**CBCC AND ADC ROOF REPLACEMENT  
05/17/2022**

**Additional Clarifications, Revisions and Requirements**

<b>Project:</b>	Bid #22061 - Sheriff Community Based Corrections Center (CBCC) and Adult Detention Center Tower Roof Replacements	<b>Meeting Date:</b>	11 May 20, 2022
<b>Facilitator:</b>	Yvette Albarran	<b>Place/Room:</b>	18 N County St 10 <sup>th</sup> Floor

SHEET NO.  
**A1.1**

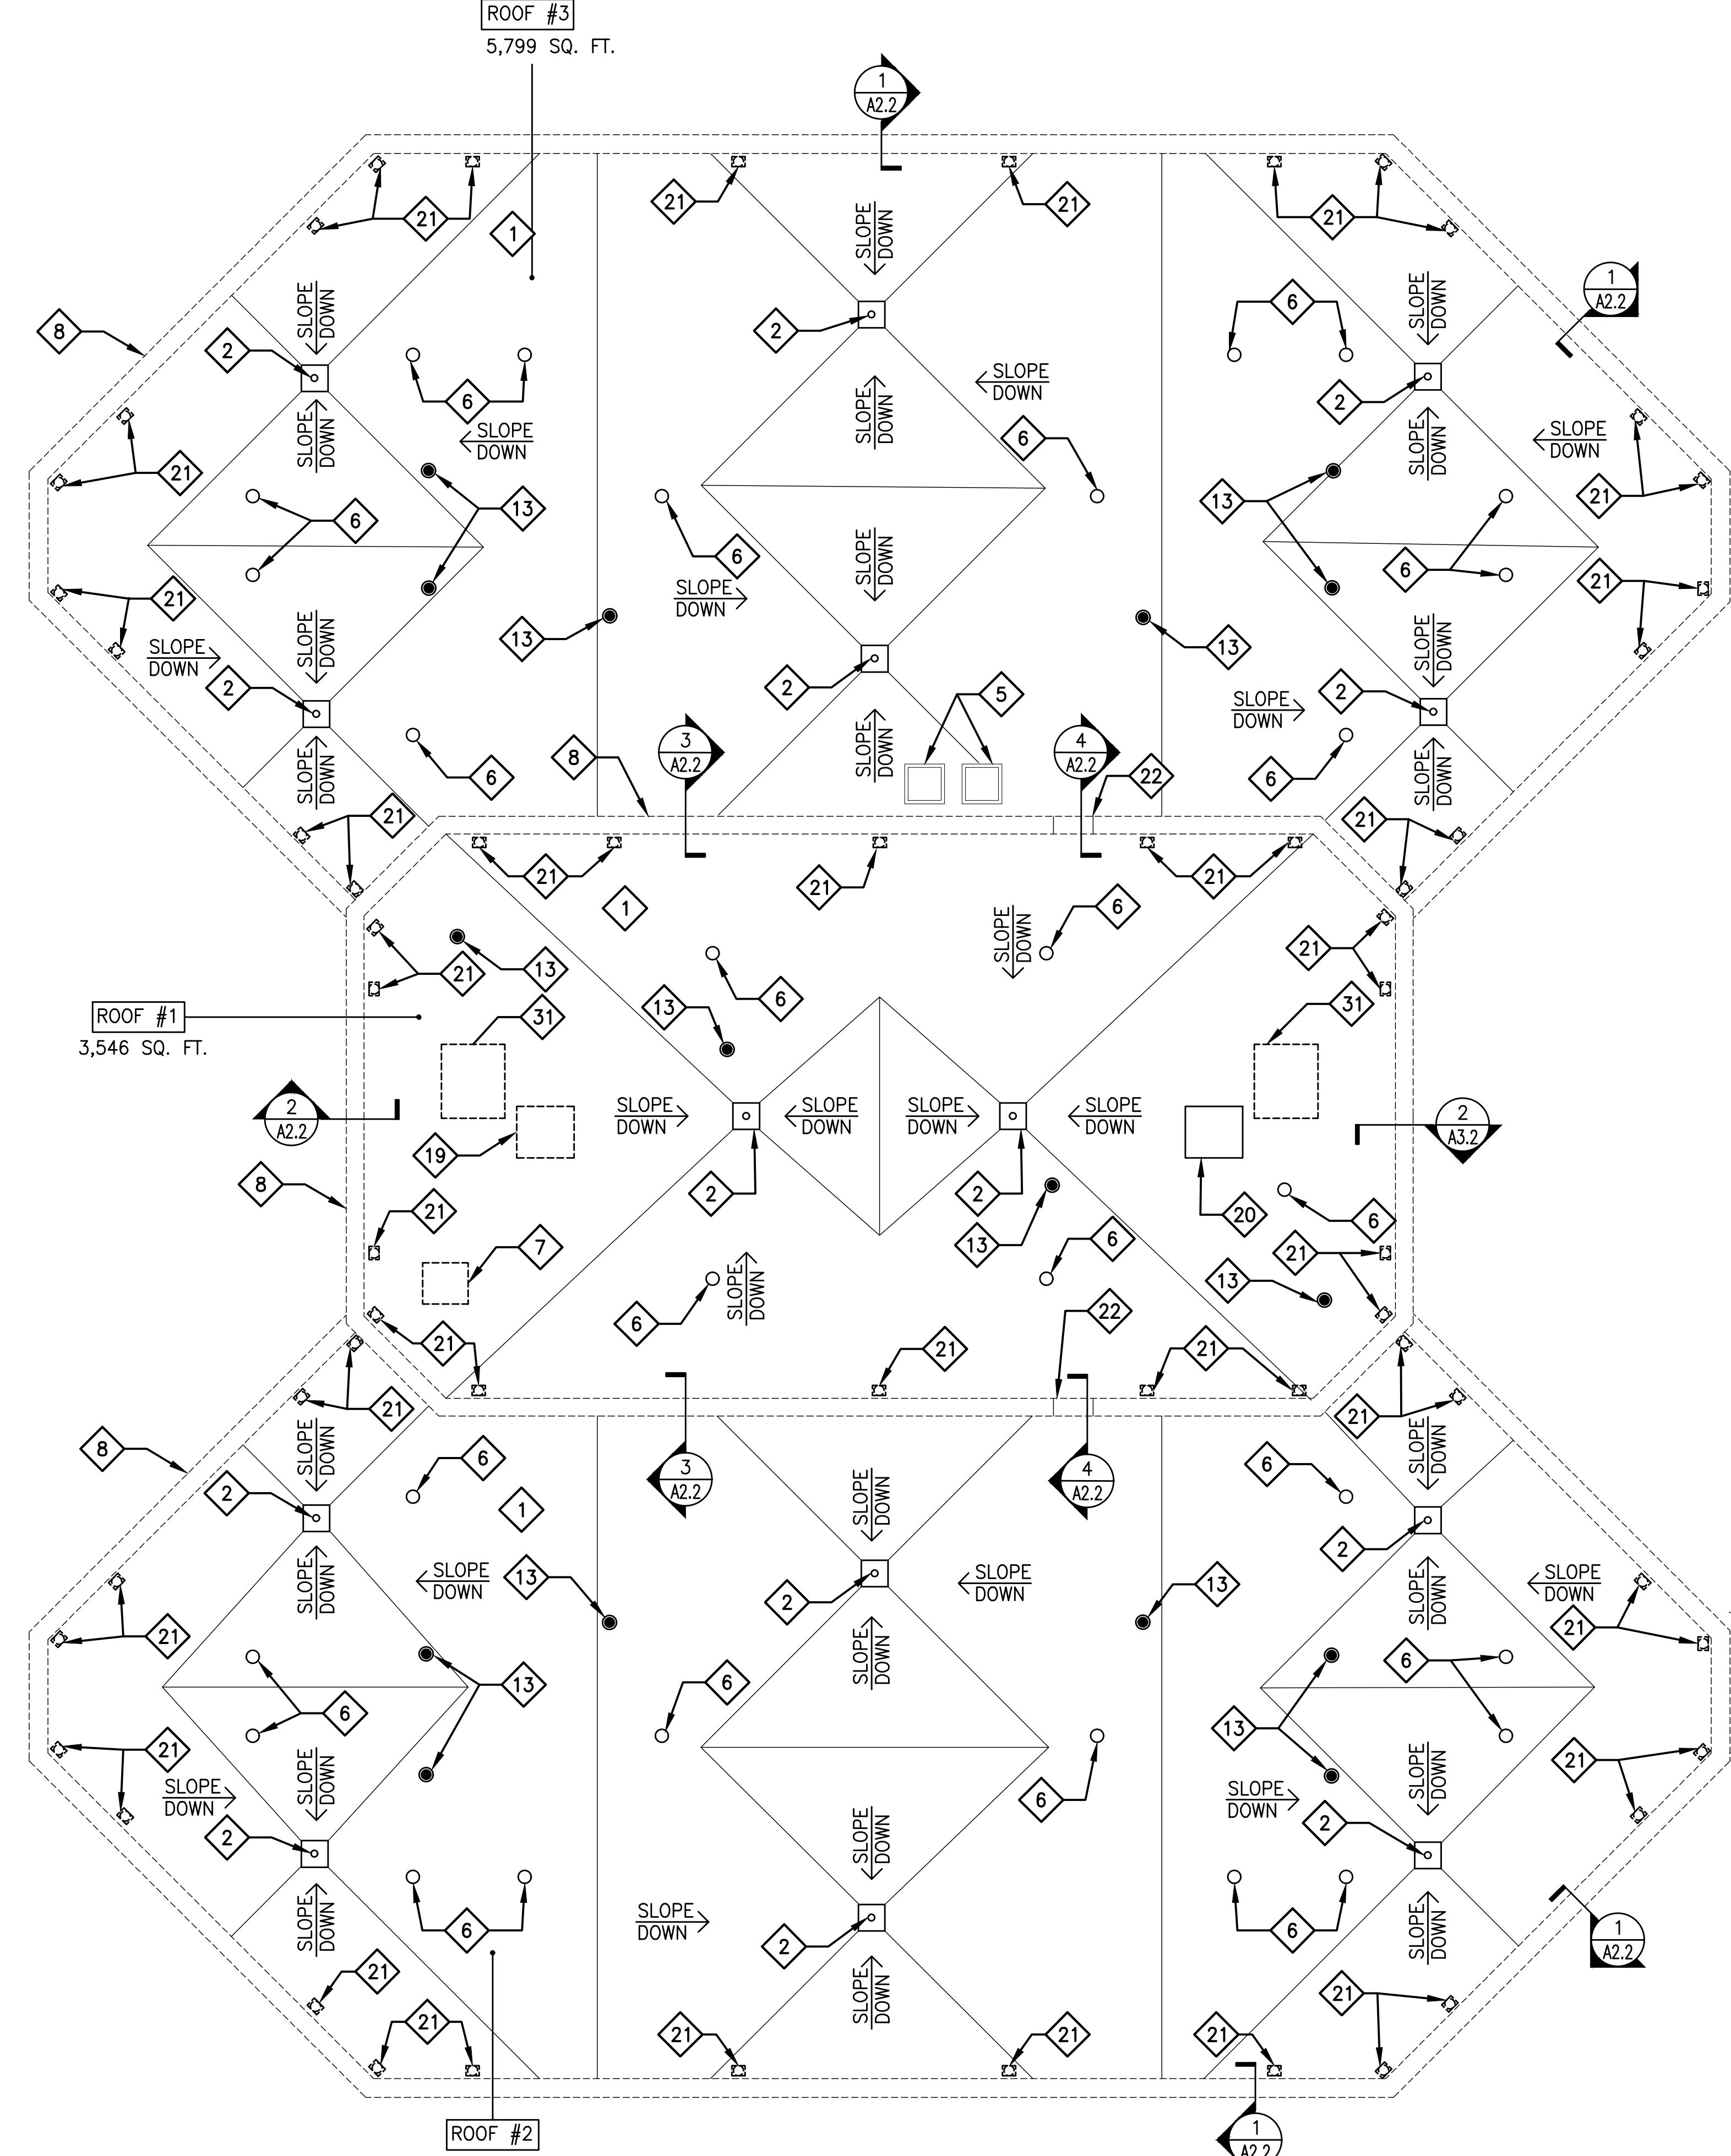
- Sheet A1.1 ROOF PLAN DEMO
- Sheet A1.2 ROOF PLAN PROPOSED

SHEET NO.  
**A1.2**

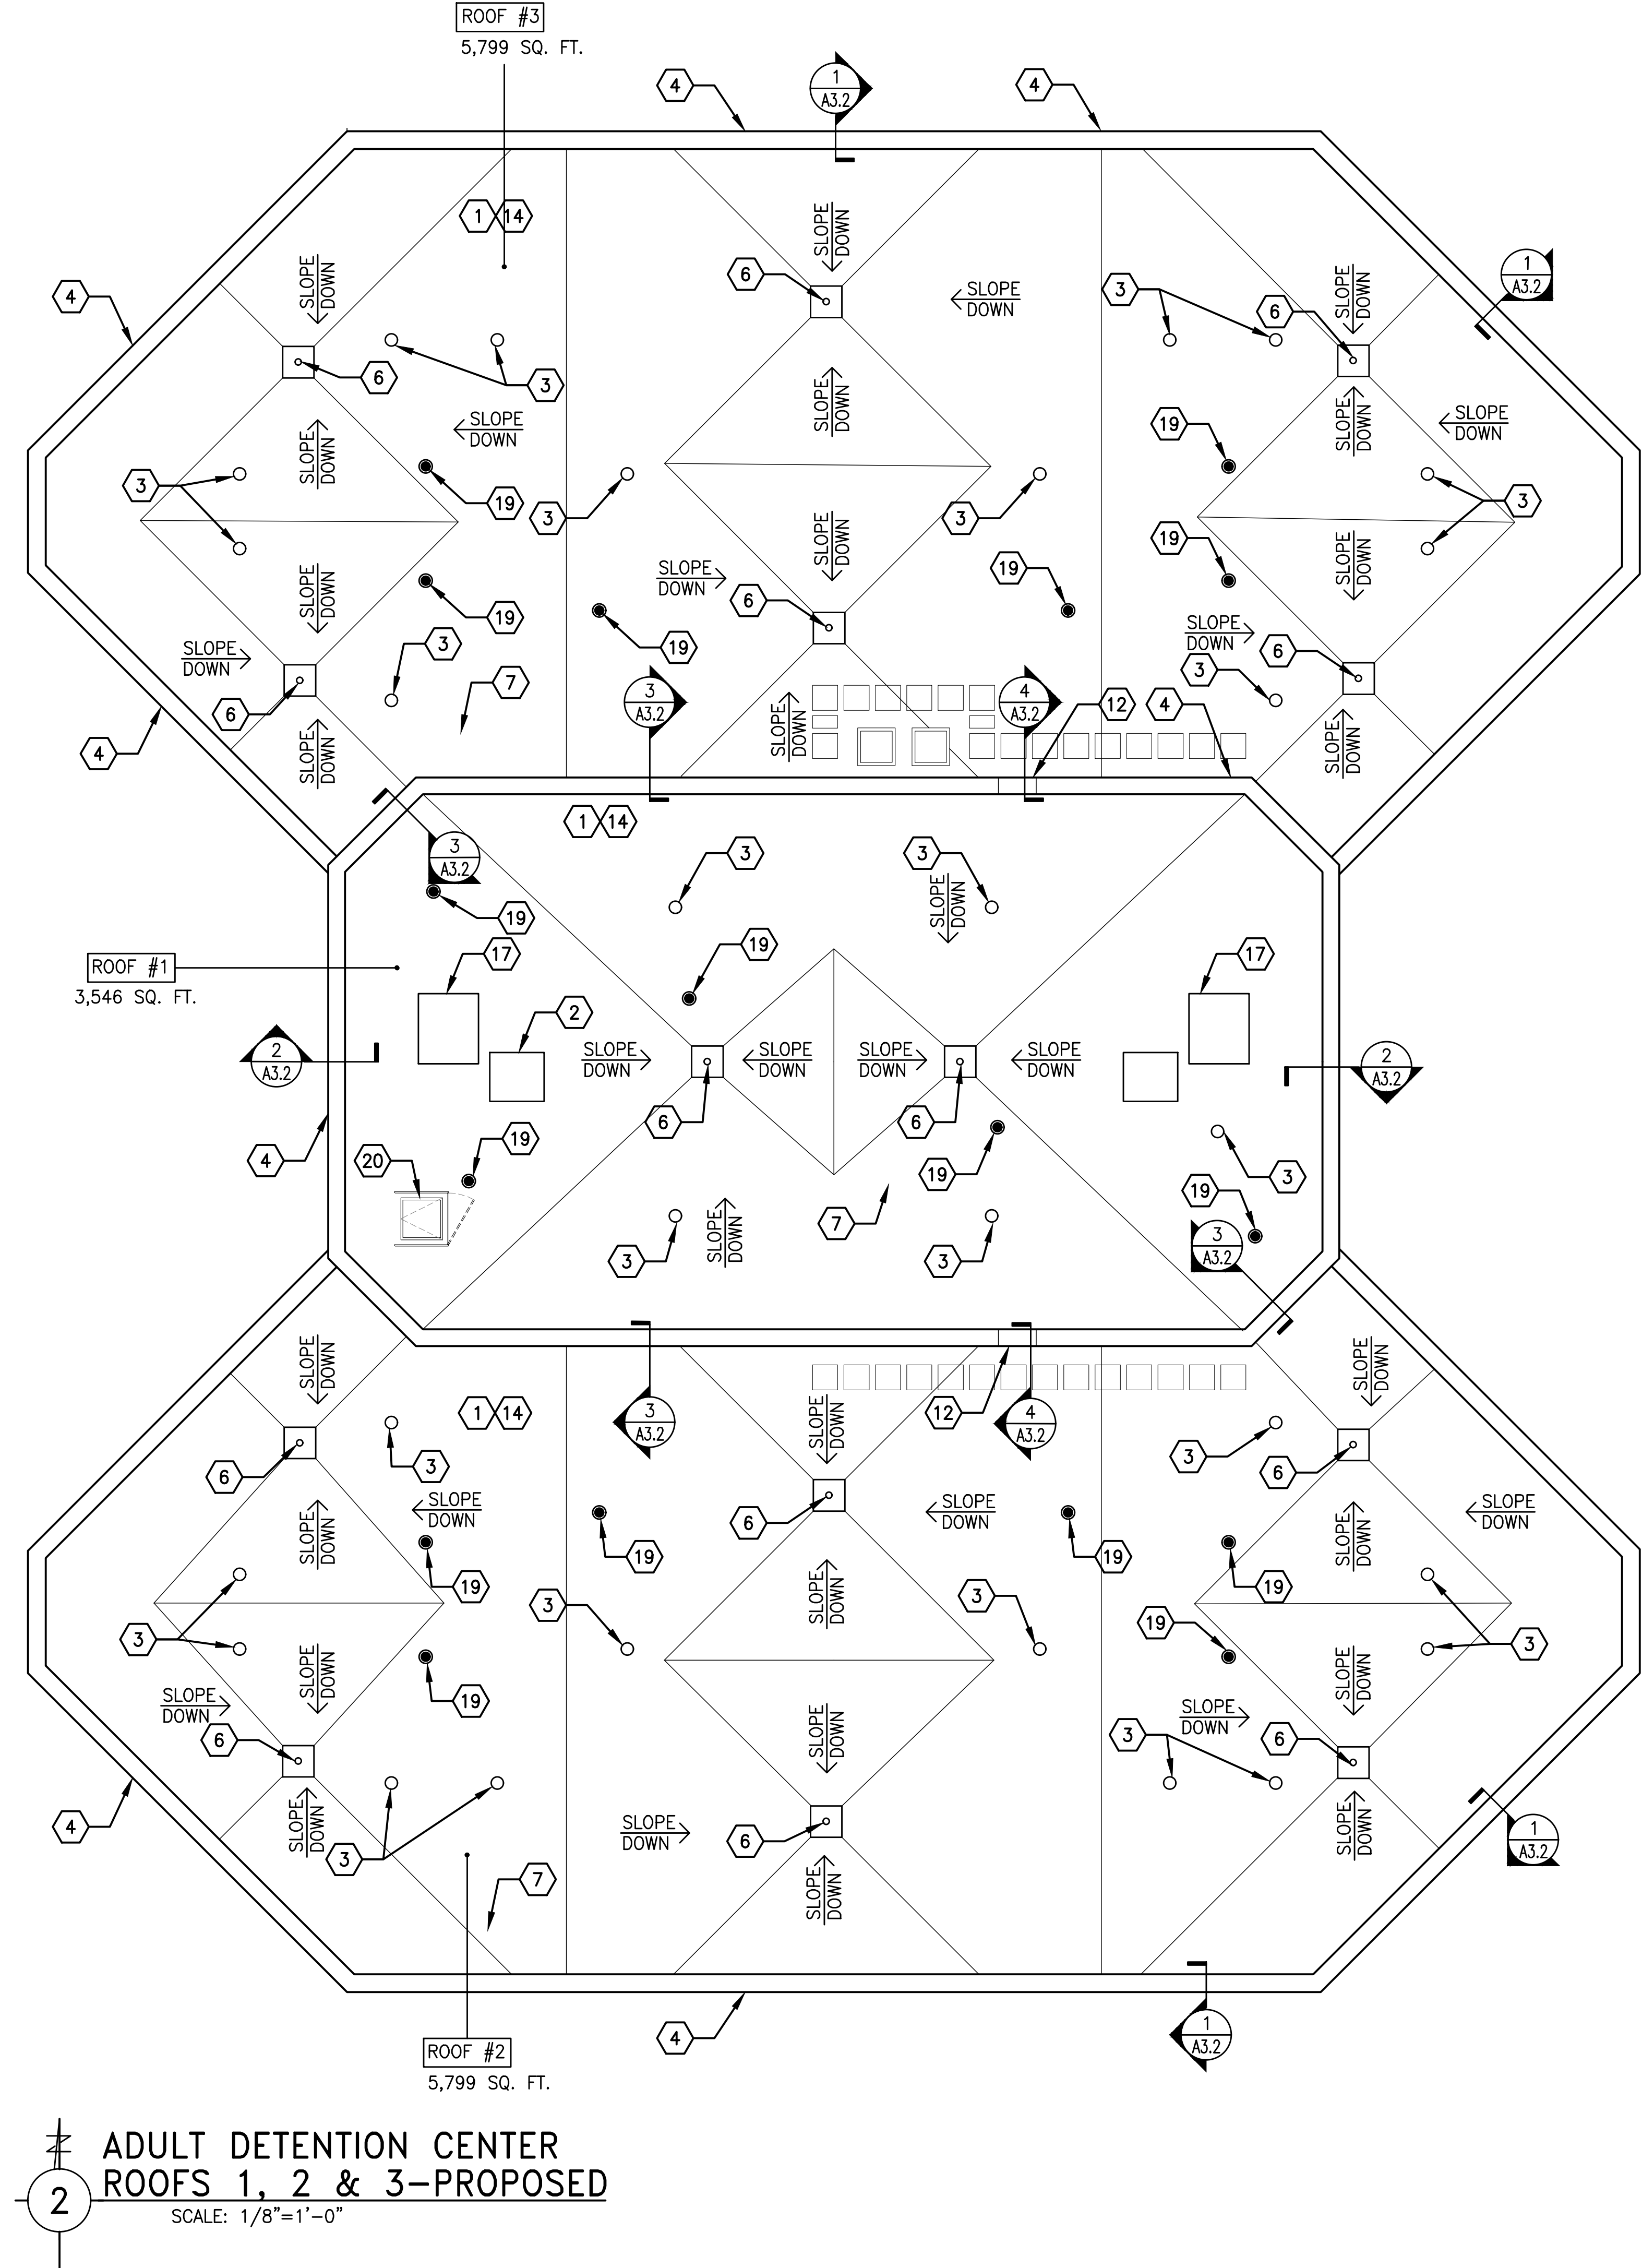
2. Allowance is only for relocation of the refrigerant lines and crack repair above 1000 linear feet. Initial 1000 LF to be included in base bids for CBCC and Babcox. Allowance only allowed for CBCC roof.

- ROD ALL ROOF DRAINS AND VENT PIPES ON ROOF AREAS 1,2 CBCC AND 1,2 AND 3 ADULT DETENTION CENTER. CLEAN OUT THE PIPES AFTER RODDING.
- CONTRACTOR TO PROVIDE A UNIT PRICE FOR REPAIR OF CRACKS IN CONCRETE ROOF DECK PER SQUARE FOOT.
- ALLOWANCE IS ONLY FOR RELOCATION OF THE REFRIGERANT LINES AND CRACK REPAIR OVER 1000 LINEAR FEET. INITIAL 1000 LF TO BE INCLUDED IN BASE BIDS FOR CBCC AND BABCOX. ALLOWANCE ONLY ALLOWED FOR CBCC ROOF.
